**COUGAR CREEK
DEBRIS FLOOD RETENTION STRUCTURE
Supplemental Information Request Round 1**

SUBMITTED TO:
Alberta Environment and Parks
and Natural Resources Conservation Board

SUBMITTED BY:
Town of Canmore

June 2017

I:\TownOfCanmore\20746\FiguresAndTables\EIA_SIR\2017\Report\AEP_Response\Figure 105 - Surface Water Local and Regional Study Areas_Revised.mxd

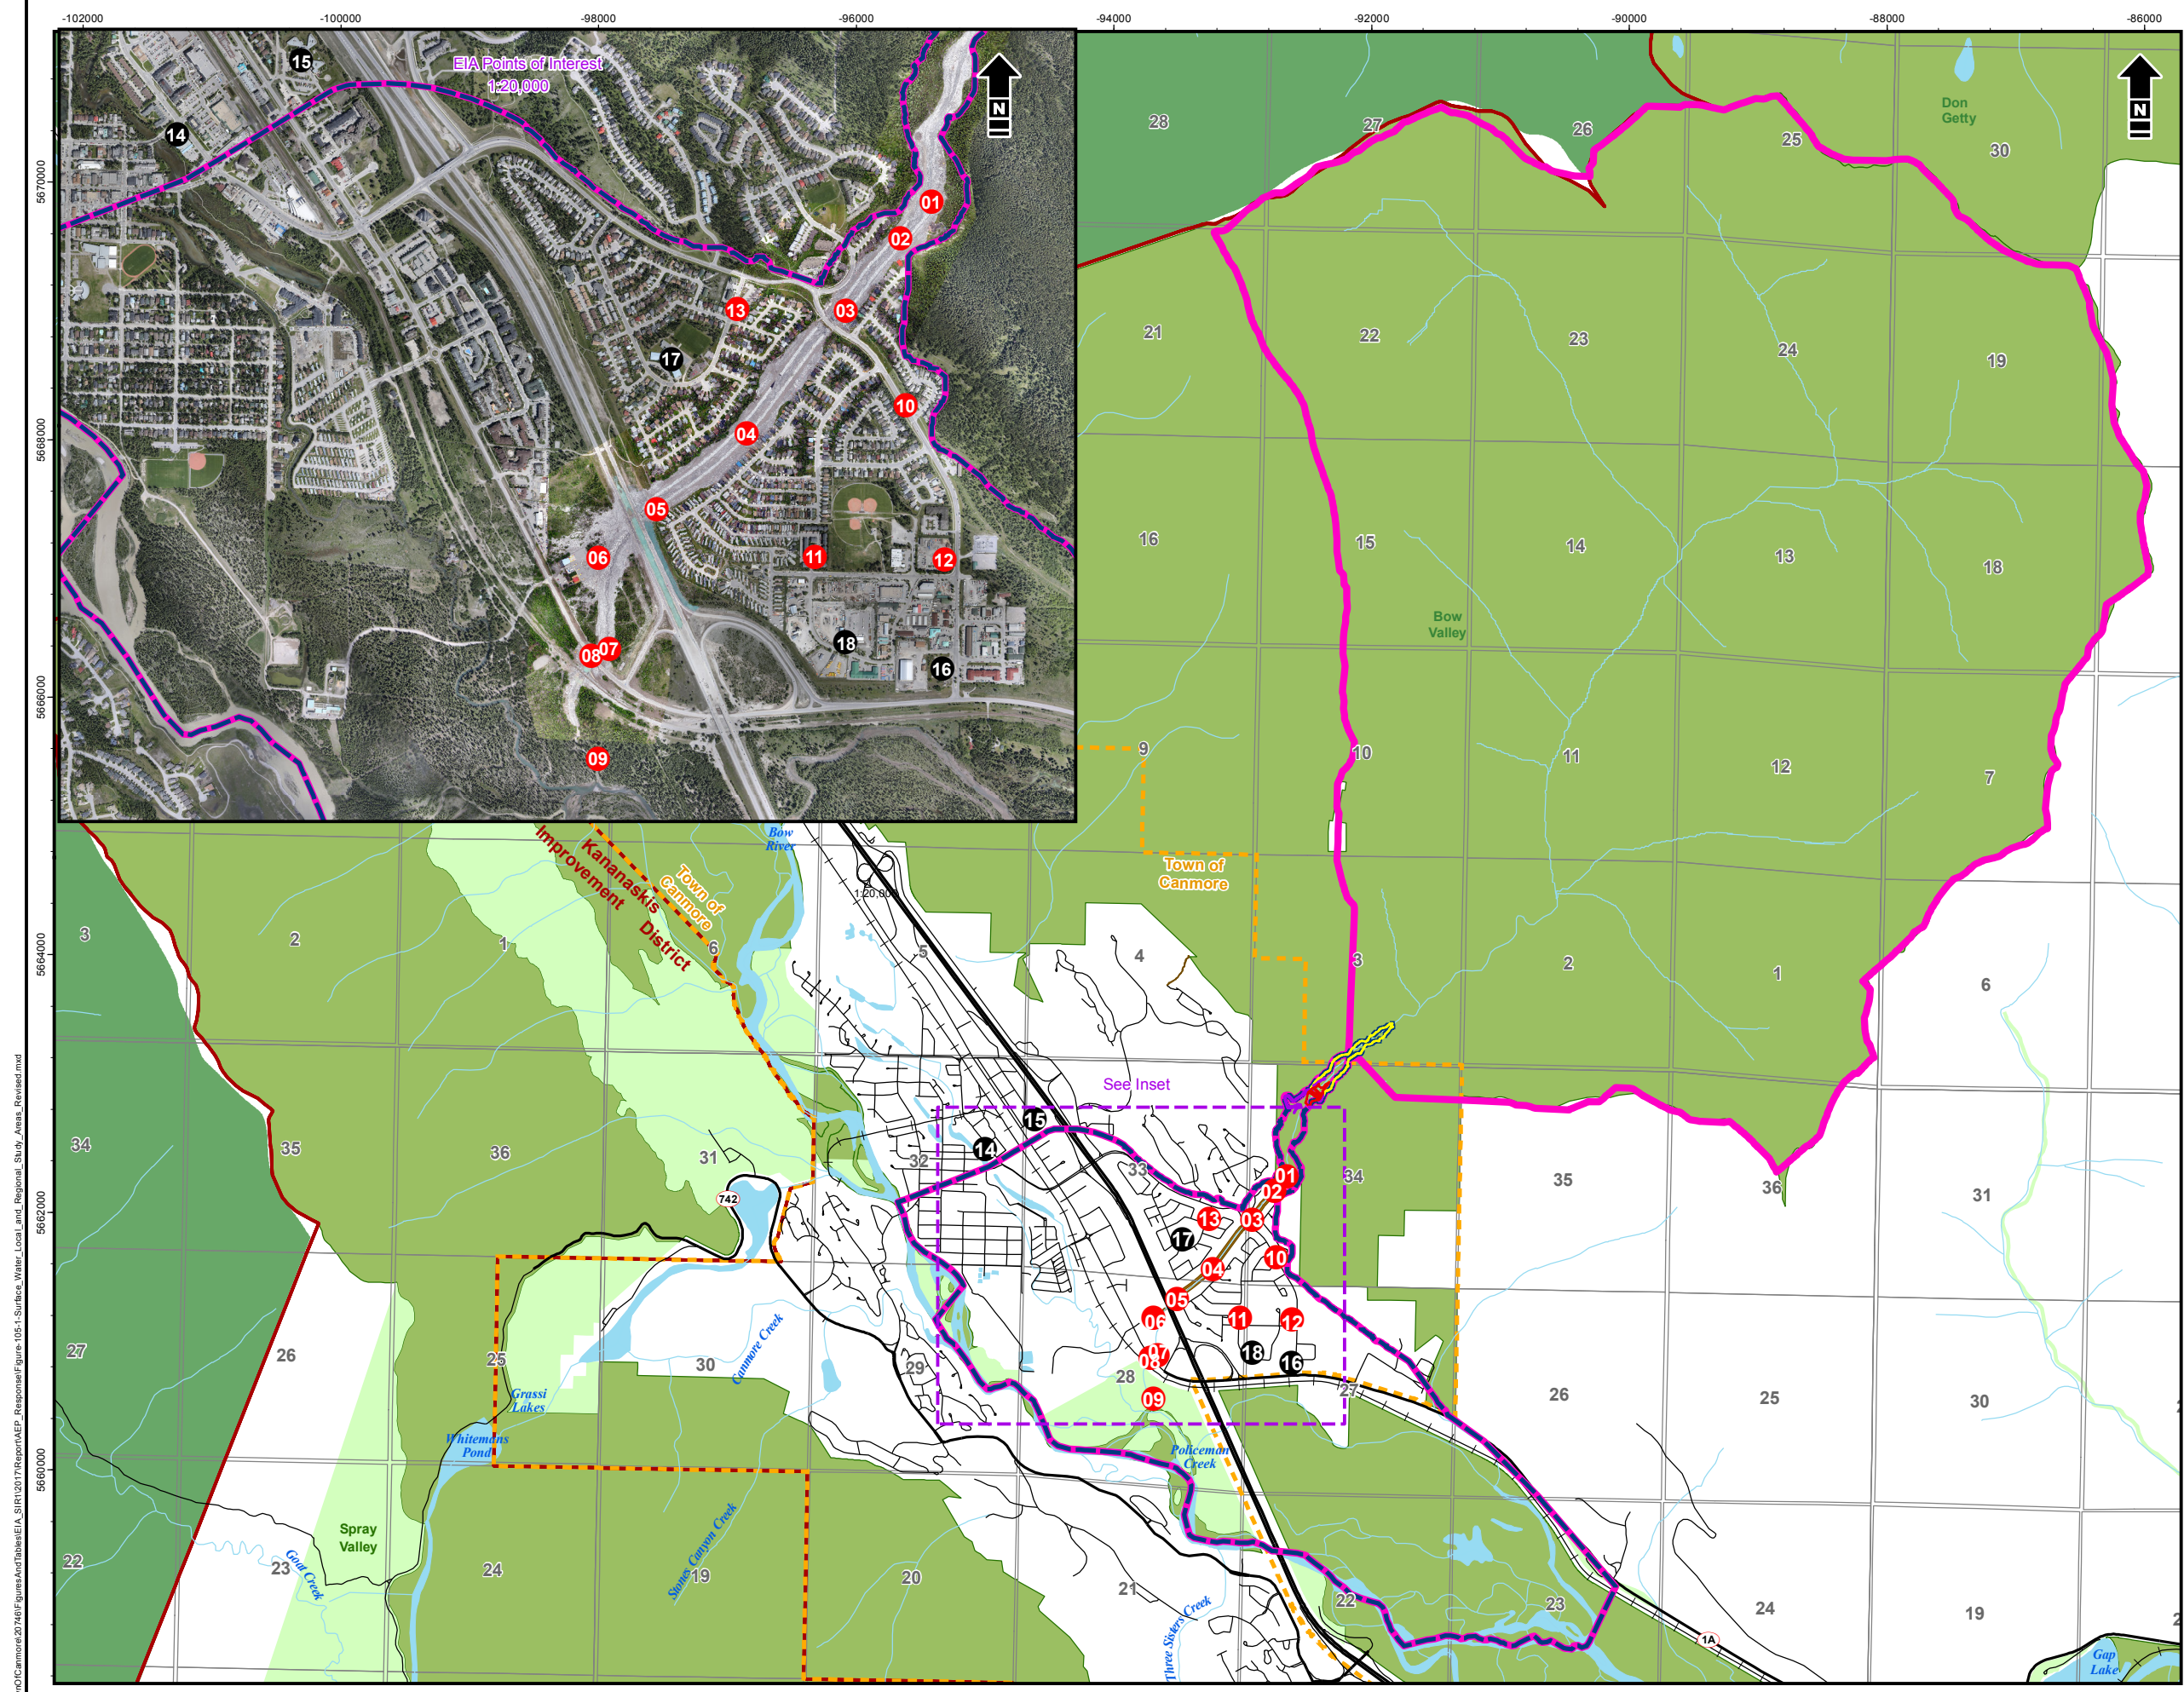
105	Volume 1, Section 6.3.2, Figure 6.3-1, Page 6-7 Local Study Area (LSA) shown on Figure 6.3-1 does not show much detail of the LSA. a. Provide a Figure of LSA showing the points of interest as shown in Appendix 4F Figure 17.
-----	--

- a. Figure 6.3-1 of the environmental impact assessment has been updated to include the information presented in Appendix 4F, Figure 17. The updated figure is included here as [Figure 105-1](#).

PROJECT: COUGAR CREEK DEBRIS FLOOD RETENTION STRUCTURE		
Figure 158-1 Comparison of Flood Wave Impact		
PROJECT No.:	16568	REV: 00
DRAWING No.:	LTMM CC-EIA-RES-001 R00

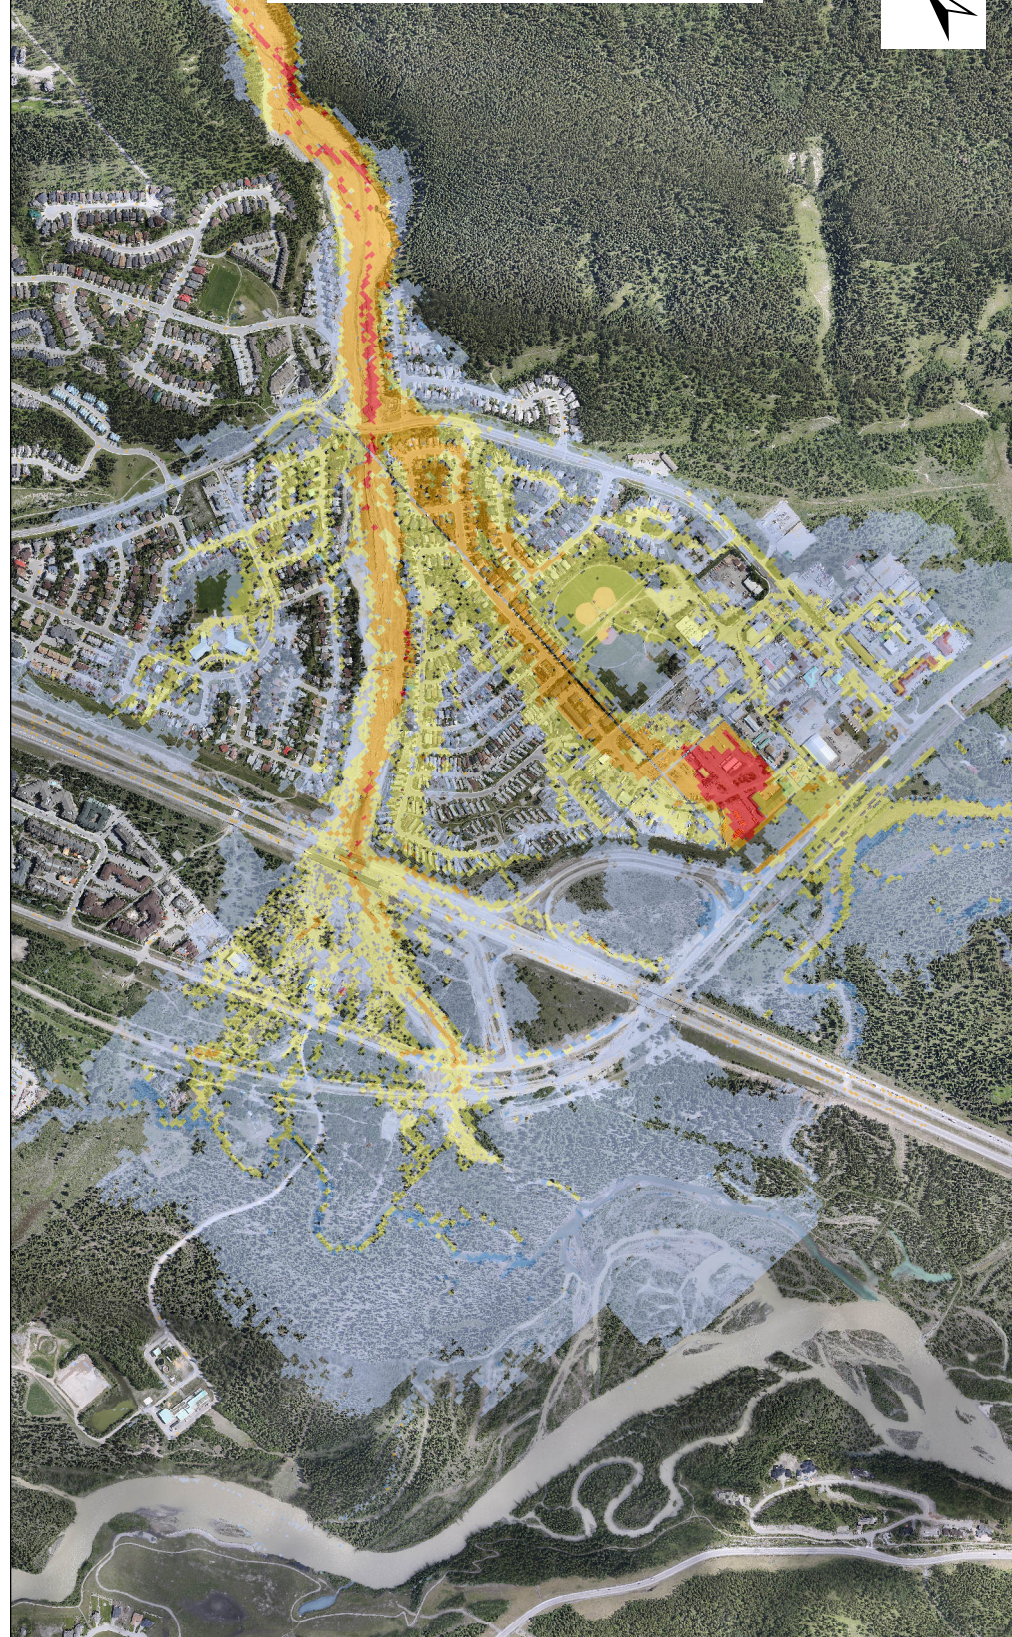
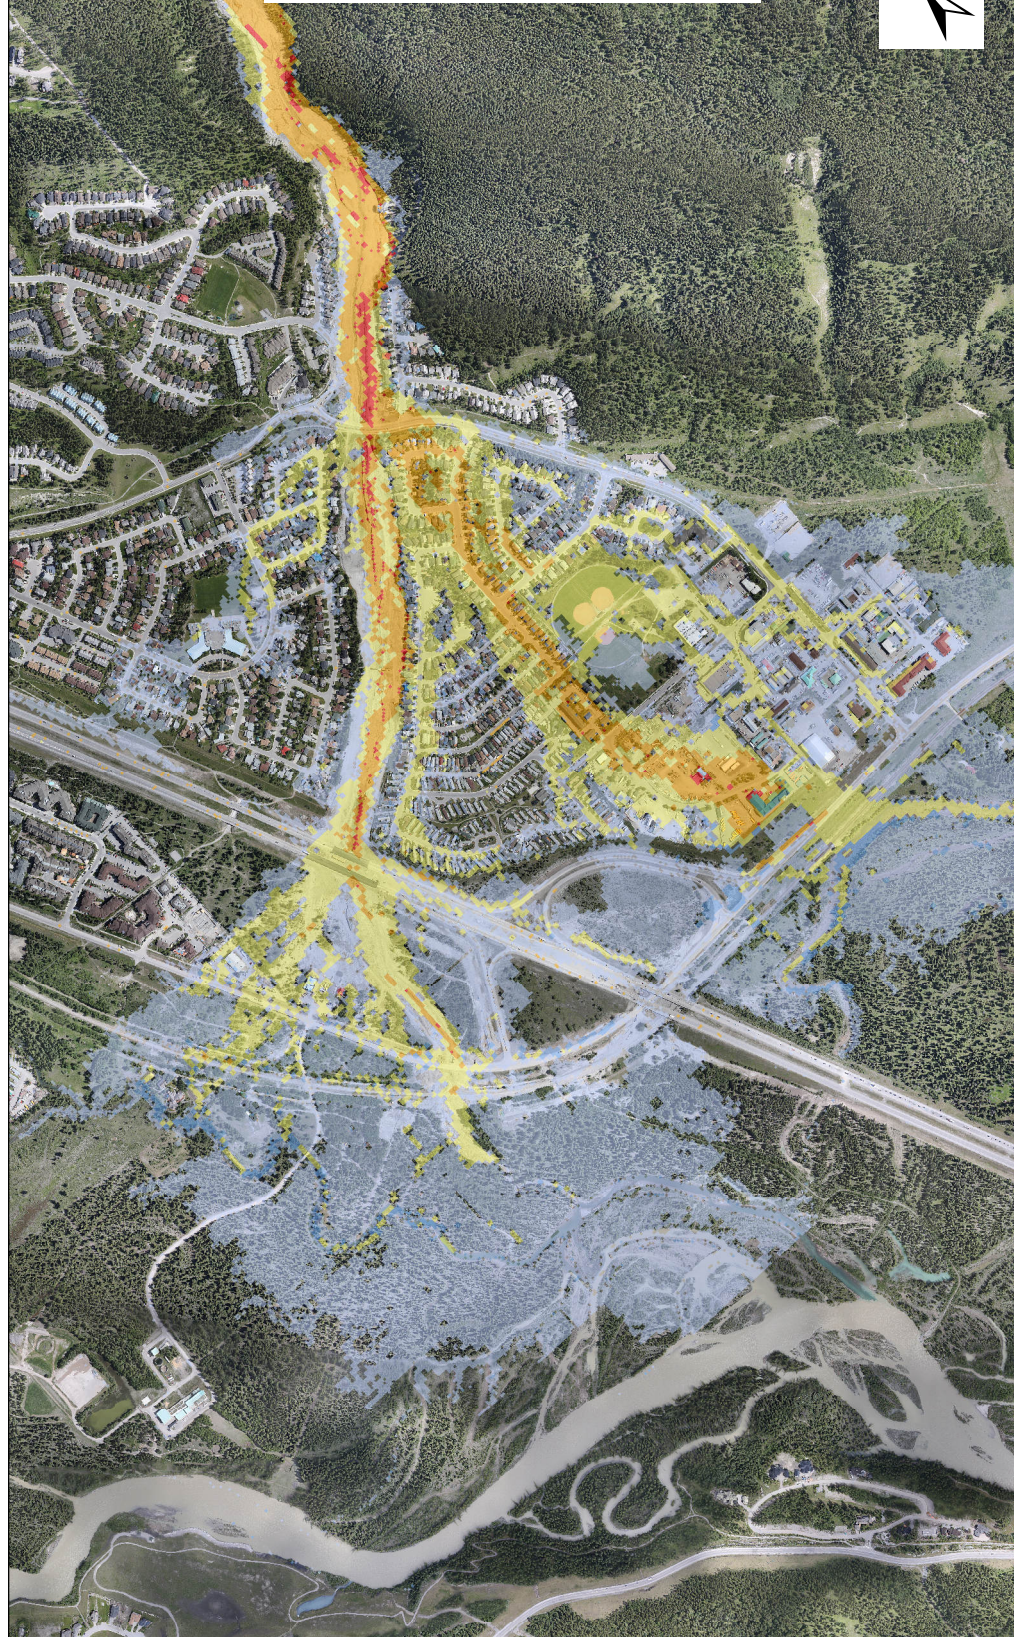
158	<p>Volume 1 Section 4.2.1, Page 4-9 Volume 1, Section 4.2.1, Page 4-10 Volume 1, Section 4.2.1, Page 4-11</p> <p>With respect to alternatives considered, Option D (no further mitigation) was rejected.</p> <p>a. How does the historical and predicted natural flood scenario compare with the dam failure scenario? I.e., how would a natural landslide dam flooding event compare to the failure of the proposed dam holding back 760, 000 m³ of water and debris? Provide a figure comparing the 2 scenarios (E.g. Drawing 11 in BGC [2014] vs. Figure 10.3-2 and 10.3-3 in the EIA).</p>
-----	--

- a. The comparison is shown on [Figure 158-1](#). This figure shows that a Structure breach scenario leads to a wider inundation area with substantially lower impact intensities compared to a landslide dam outbreak flood (LDOF) scenario as assumed in the hazard assessment by BGC Engineering Ltd. (BGC 2014). [Figure 158-1](#) includes two LDOF scenarios for 300 to 1,000-year (Scenario 4) and 1,000 to 3,000-year (Scenario 5) return periods.

I:\TownOfCanmore\2017\FiguresAndTables\EIA_SIR\12017\Report\AEP_Response\Figures\75-1-Dam_Breach_Inundation_Map_Clear_Water_Discharge_Calculation_from_Dam_Breach_Scenario.mxd

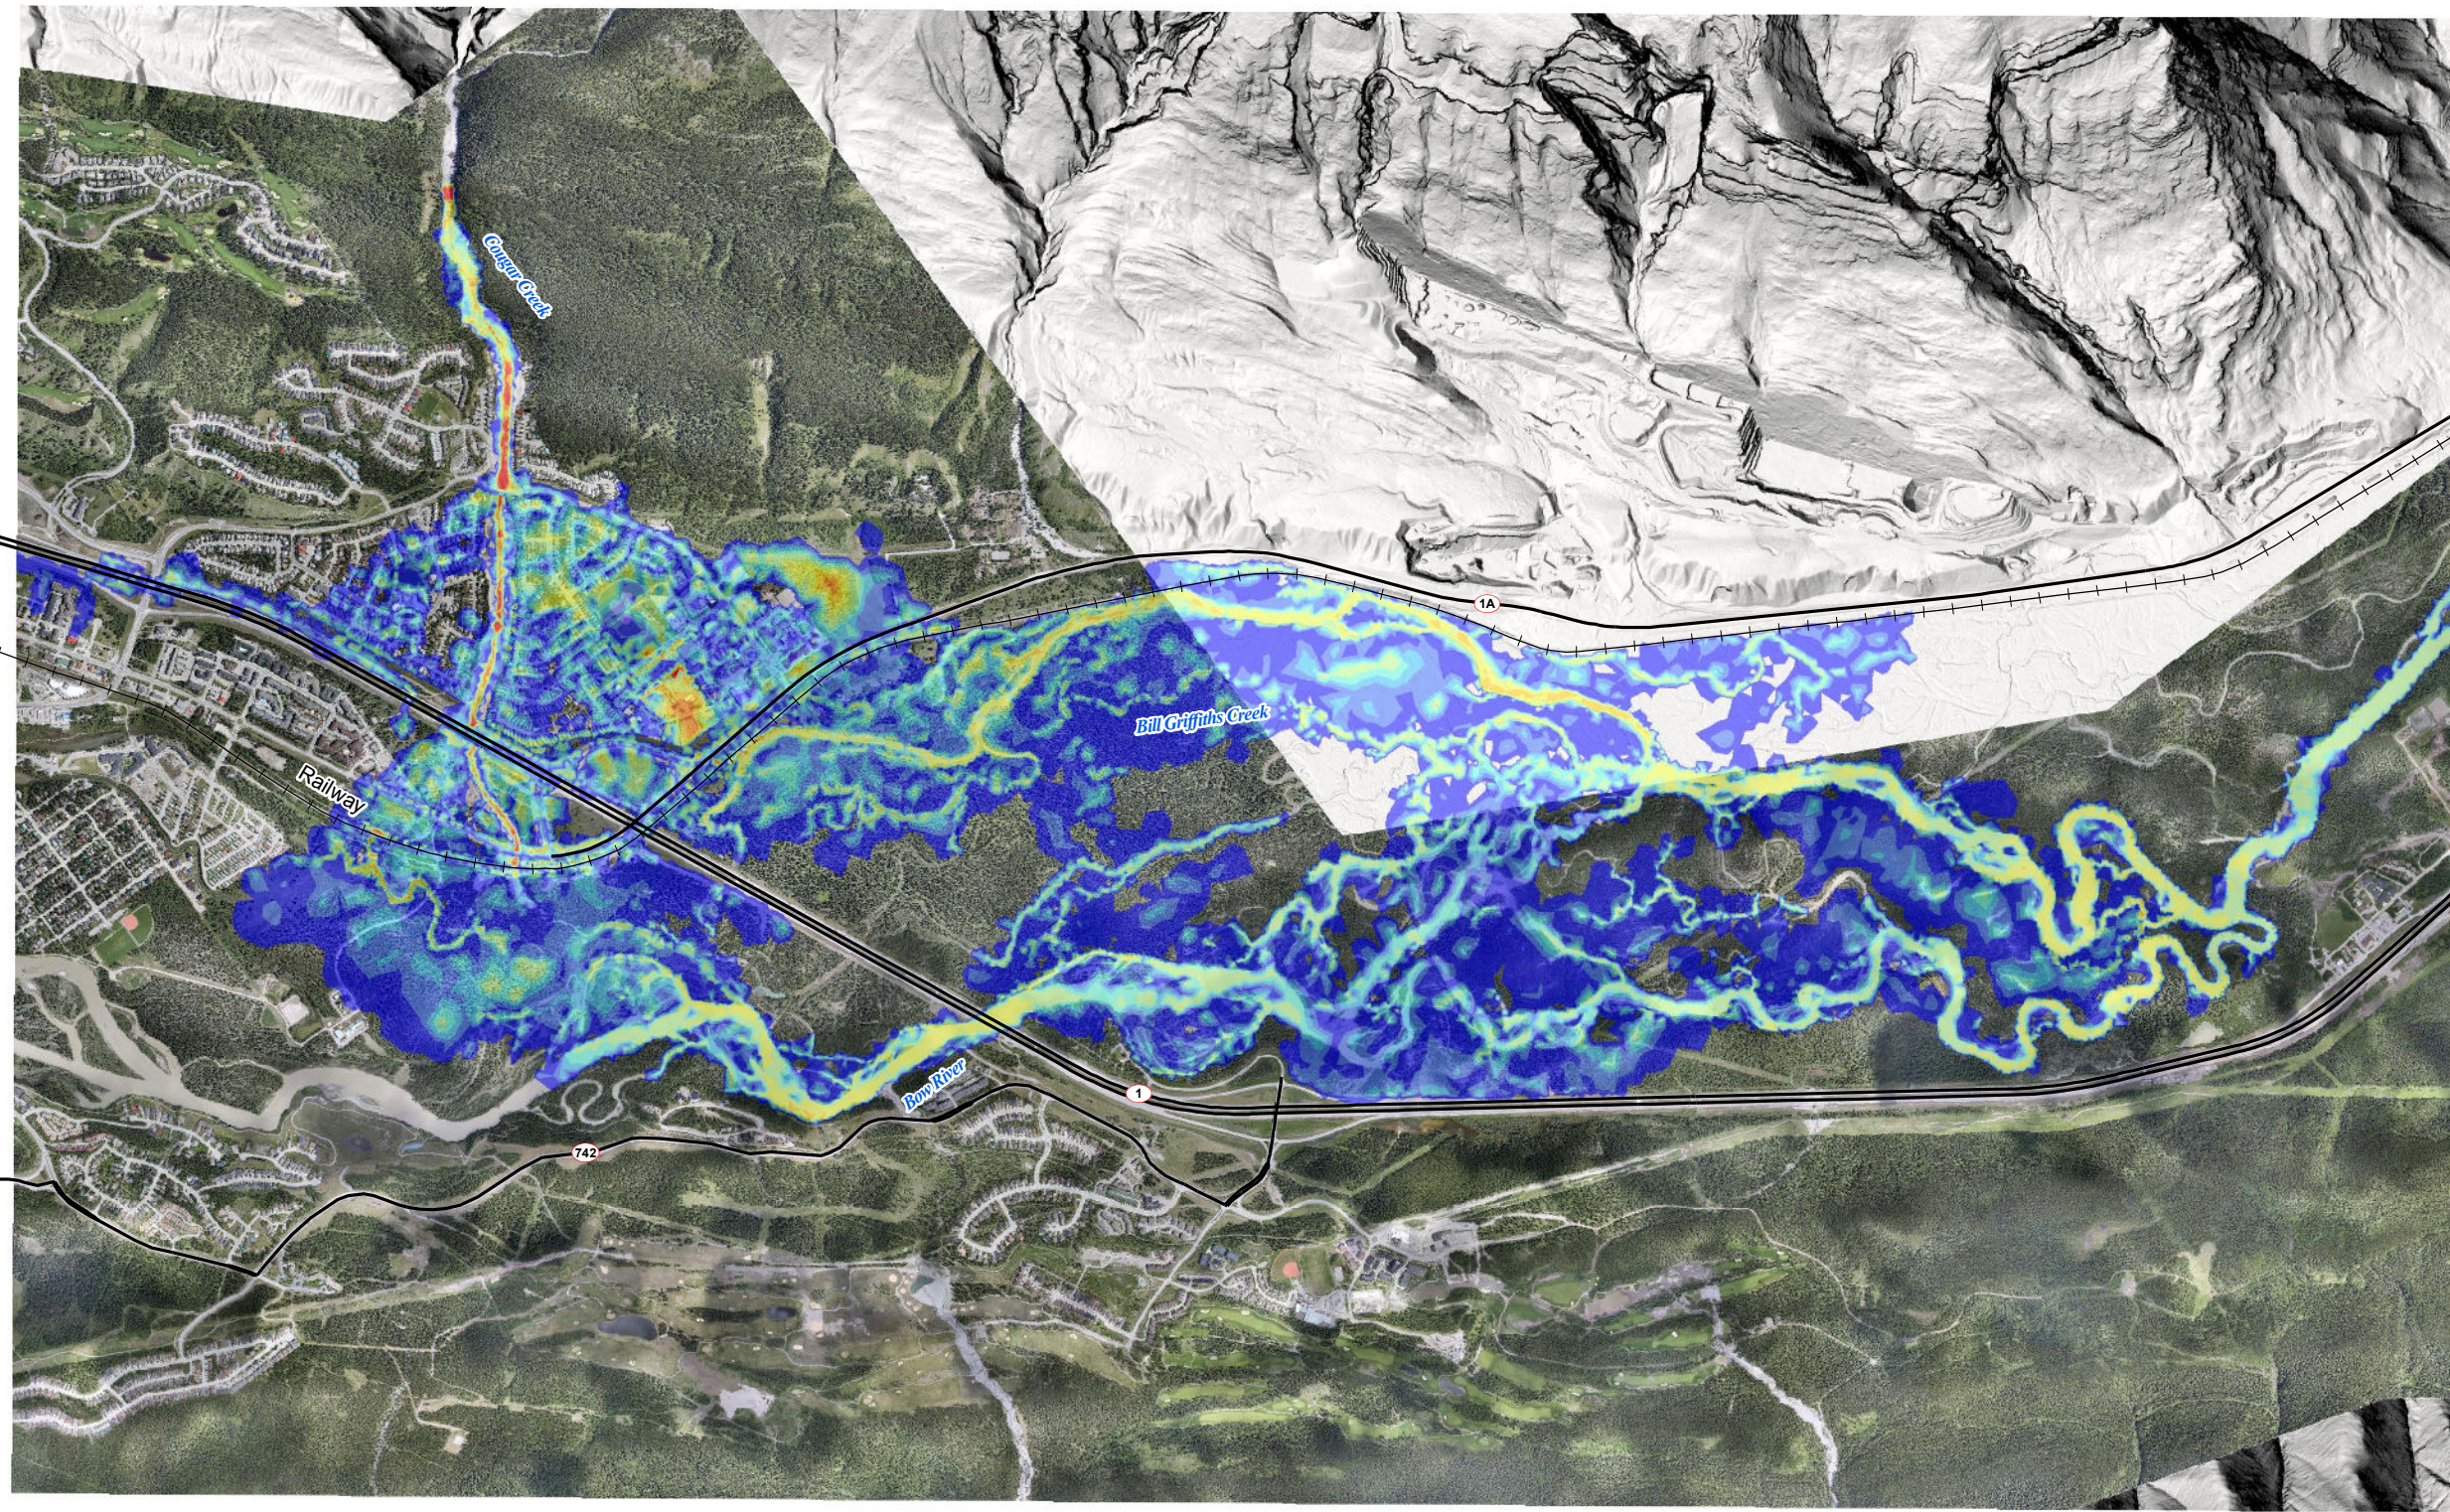
175	<p>Volume 1, Section 10, Figure 10.3-2, Page 10-8 Volume 1, Section 10, Figure 10.3-3, Page 10-9</p> <p>The scale of the map is not sufficient to provide the full extent of the inundation area. Based on the modeled flows and depths, the water would be expected to reach the Bow River.</p> <p>a. Provide figures that show the extent, routes and the locations of confluence with the Bow River.</p>
-----	---

- a. The inundation analysis was extended to provide the extent of the inundation area. Three new maps are provided:.
- [Figure 175-1](#) shows the clear water discharge for the breach of the Structure only.
